HORD ARCHITECTS

Date: October 25, 2023
Subject: Trumann Fire Station
801 West Main St., Trumann, Arkansas 72472

Addendum # 1

SHEET NO.:
T101

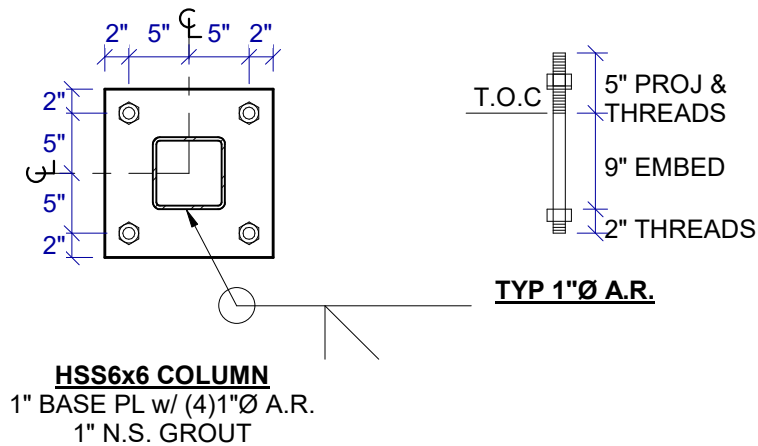
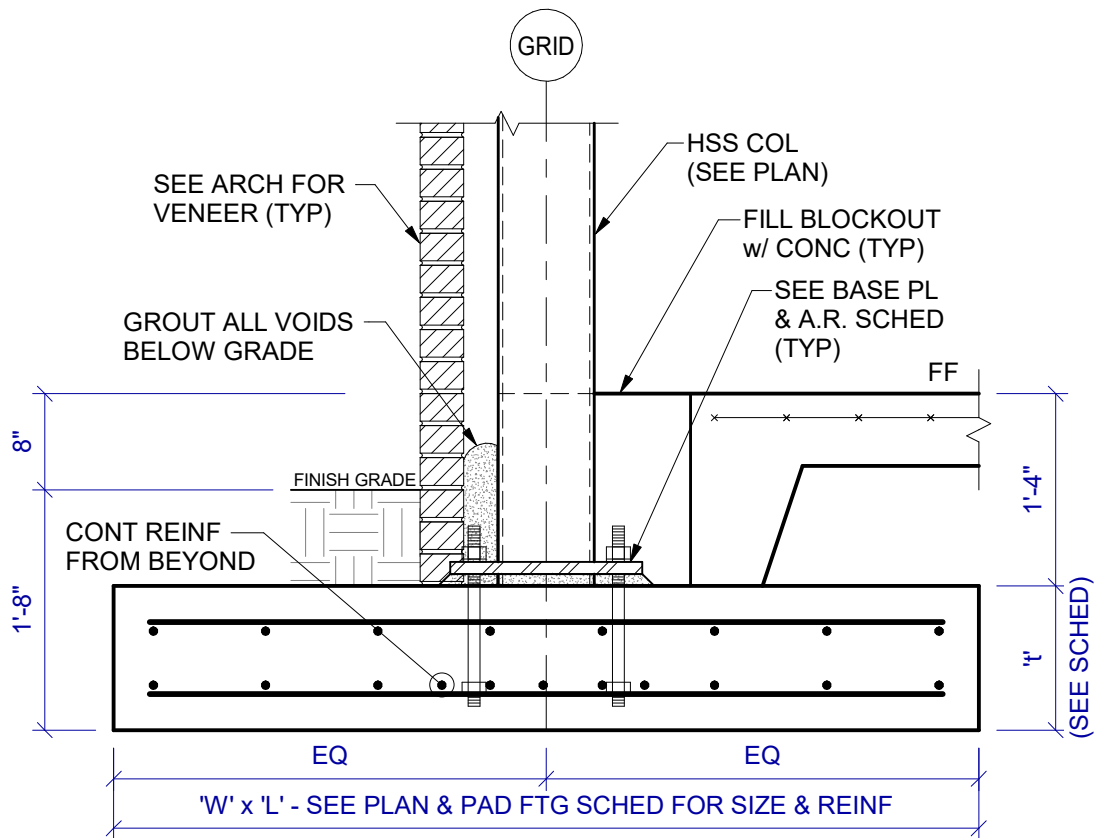
1. Deductive Alternate No. 3: State the amount to be deducted from the Base Bid to install the originally specified PBR screw-down roof panels in lieu of the Batten-Lok standing seam panels in Article A of Addendum #1. As part of Deductive Alternate No. 3, omit 20 year warranty requirement.
2. Replace the Bid Form with the attached revised Bid Form document.
3. Replace Project Manual Section 01030 – Alternates with the attached revised section dated October 25, 2023.
4. Replace sheet T101 with the attached revised sheet T101, Rev. 1, dated 10-24-2023. Revision is for alternates only.
